Additional Information on Entry & Exit Access to Farleigh House and number of affected properties

Dr M J Smith - on behalf of Farleigh Village Residents

Fig 6. 1st 100 metres of TR is single track and all derestricted from this point

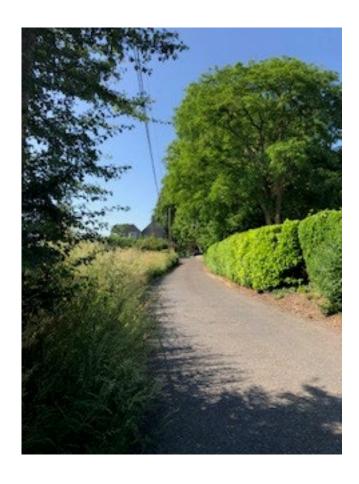
HOWEVER this fails to acknowledge or show the "true" entry route leading to Farleigh House from the A366 onto Tellisford Road (TR) - not included on their map. This is a narrow, steep and dangerous junction into a small, derestricted country lane, single track for the first 100 metres with no passing places, going uphill and blind on entry (see fig. 1 Map, and figs. 2-7 below)

This has always been a potential accident black spot both for vehicles turning into TR cutting across busy traffic coming up the A366 and often causing a significant tailback in the other (easterly) direction, and also for vehicles coming down TR as cars/vans/lorries/farm traffic frequently cut the corner when turning in (see fig. 5)
